NRC Staff Questions with Problem Statements

(Enclosure 6 to ML080510080 phone call summary of October 31, 2007 and November 29, 2007 phone calls with Alion)

Alion Follow-Up Issues (Updated 2/11/08)

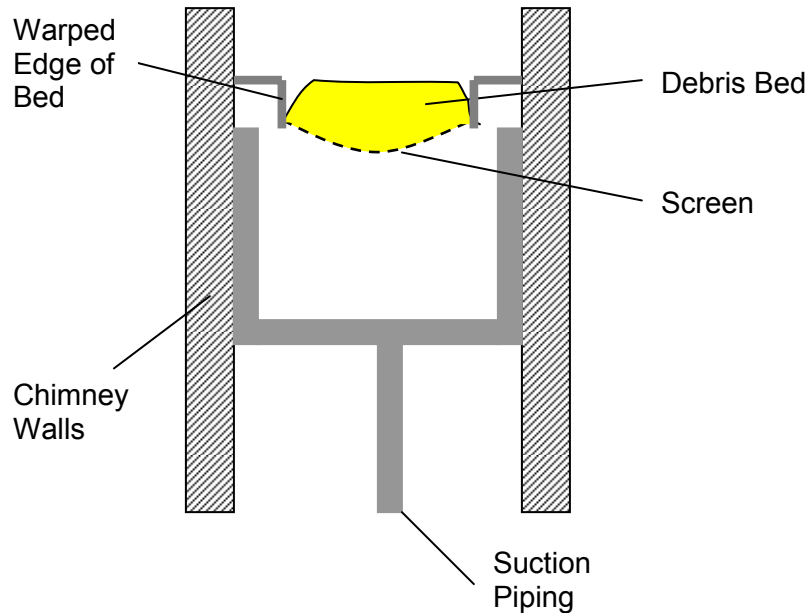
9. In two tests that were completed during the staff's visit, inward warping of the upper surface of the debris bed away from the walls of the "chimney" was observed, as shown below in an idealized cross section (not to scale). Such warping of the debris bed could result in a significant amount of the flow passing through the thinner cross section of the debris bed nearest the chimney walls.

In light of the discussion above, Alion should (a) demonstrate that flow diversion through the thinner debris bed cross section caused by circumferential warping has not had a significant adverse impact on testing conducted at VUEZ and (b) describe measures taken to prevent or minimize this observed phenomenon in future testing.
